AIRSPACE CHANGE PROPOSAL ACP-2019-58 LLANBEDR AERODROME DANGER AREA – SUMMARY OF DESIGN OPTIONS AND INITIAL APPRAISAL

Figure 1 – Draft airspace design Option #1 for ACP-2019-58, Llanbedr Danger Area (DA)

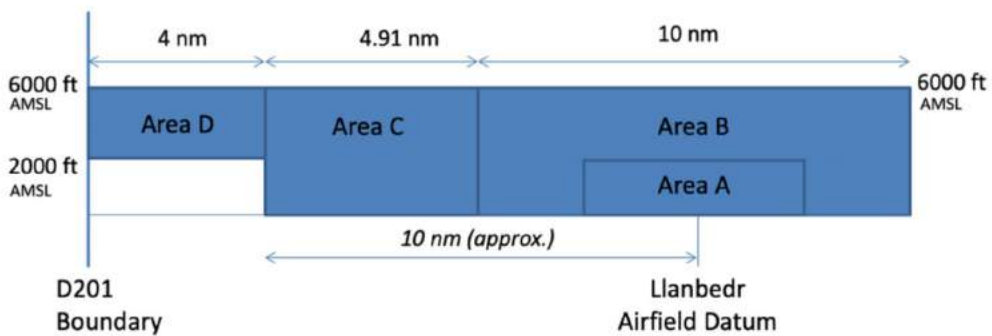
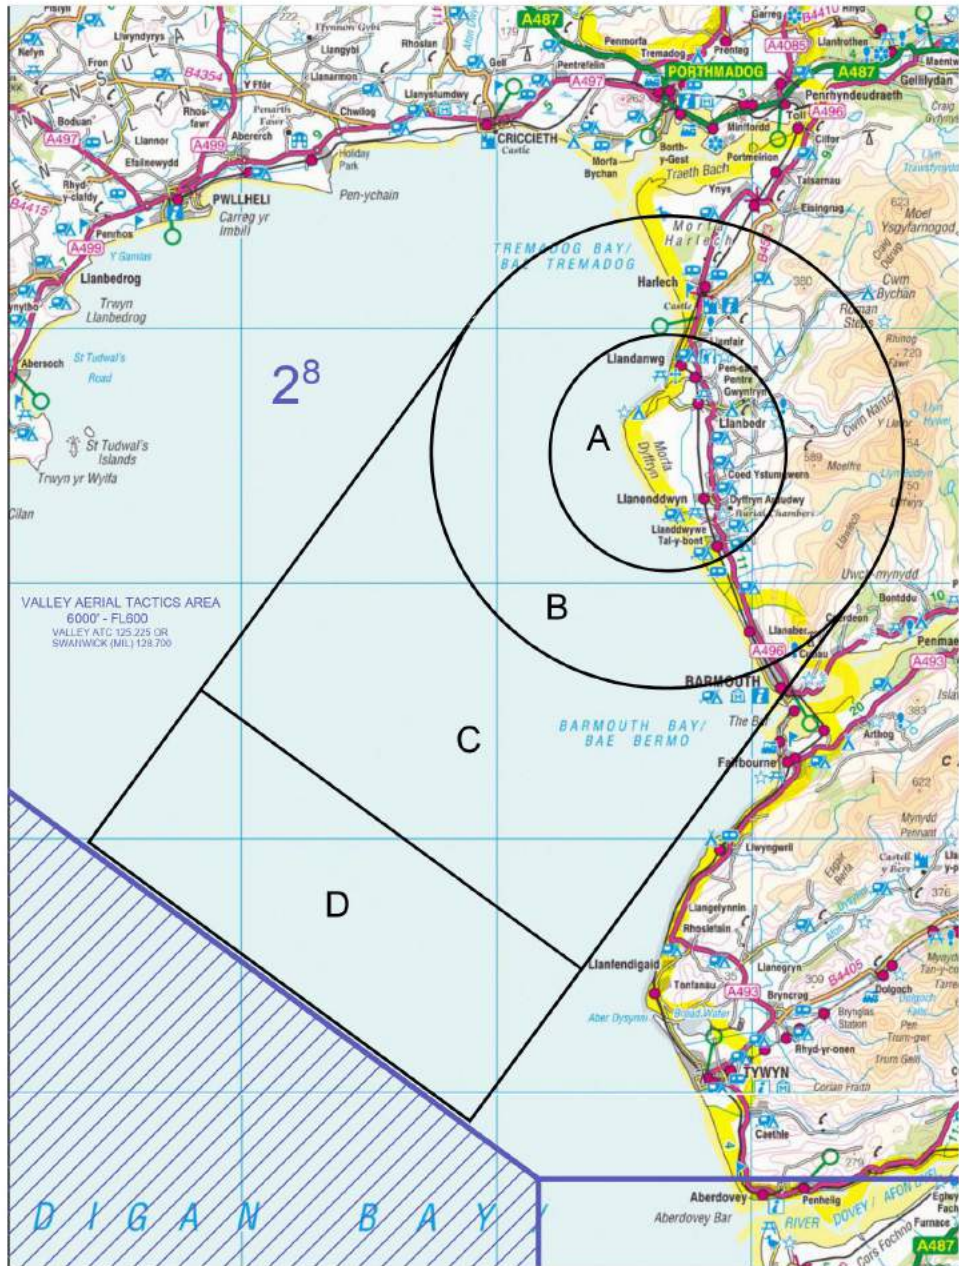
1. *Both designs only leave a small portion of Glass G airspace (4nm wide) to transit underneath the proposed DA.*

2. *If the DA is active, D201 trials might be restricted as NATS Aberporth lose the ability to exit the Danger Area in the NE portion of D201J whilst conducting profile set-ups on a South Westerly run in.*

3. *The design calls for a maximum vertical extent of Alt 6000ft, but the Transition Altitude in the area is 3000ft. Normally, only where a DA is designed to support firing of munitions is the vertical extent represented as an Alt. For everything else, it is normally a Flight Level if above the Transition Altitude.*

4. *Airspace Containment: (a) the purpose of this DA is to segregate the activity from other airspace users but fails to mention how each design does this, and (b) the lateral dimensions within each design does not explain why it has to be that wide or that altitude. If the DA is being used for containment, then (i) what navigational accuracy is associated to these nominal routes, (ii) how far are they from the edge of the DA, and (iii) why is this considered the minimum necessary to protect others?*

5. *As to date there is no LOA in place for NATS Aberporth to agree transfer of control if the UAV platforms are entering the D201 complex. NATS Aberporth would expect it to be at the boundary of D201J.*

The 4nm "tunnel" is a feature of the Temporary Danger Area (TDA) that was arrived at after previous consultation with stakeholders^{1,2} and we have decided to promulgate the same design feature as part of the permanent Danger Area design options, but we remain open to considering alternative suggestions and would welcome supporting evidence to help consolidate the design.

We have made a forecast of future business and anticipate that we will need to activate the Danger Area on approximately 100 days per year, but that Areas C and D that might impact on the north-east portion of D201J will only need to be activated approximately 33% of the time – i.e. once every 10 days or so. We also anticipate that operations in all areas of the proposed Llanbedr DA will only exceed 2000ft altitude on a similar number of days. We therefore believe there is a great deal of scope for test activities within the Llanbedr DA and D201 to safely co-exist without impact on either party.

With regard the vertical dimensions, RAF Valley aircraft operate on the Regional Pressure Setting (RPS) when they are conducting their medium level activity and OC STANAT has confirmed that expressing the upper height as XXXX ft as opposed to Flight Level (FL) XX will make it easier for RAF Valley to safely deconflict.

The lateral and vertical dimensions of both Danger Area (DA) options are needed to accommodate the flight test requirements of a range of different novel aerospace systems and the justification for each has been detailed in the formal Stage 2A Options Development document that can be accessed via the online portal. This document also describes outline Air Traffic Management principles that are expected to apply for both design options.

With regard to airspace segregation, none of the areas of the proposed Llanbedr DA will be permanently active and will only be activated by Notice to Airmen (NOTAM) when novel aerospace flying activities are due to take place (as is also the case with D201). There is a safety advantage in having a permanent Danger Area as opposed to a Temporary Danger Area as it will be published in standard Aeronautical Information Regulation and Control (AIRAC) documentation as well as being promulgated via NOTAM ahead of activation. Snowdonia Aerospace will also work actively with other local airspace users – e.g. via the regular RAF Valley Airspace Users Symposium – to raise awareness of Danger Area activities at Llanbedr.

We have had discussions with [REDACTED] to discuss multiple aspects of coordination for activities in D201 and the Llanbedr DA, relating not only to drones but also to potential Spaceport operations. With regard air traffic management, we also see the transfer of control being at the boundary of D201J if the drone is entering the D201 complex and that the details will be formalised within a LOA.
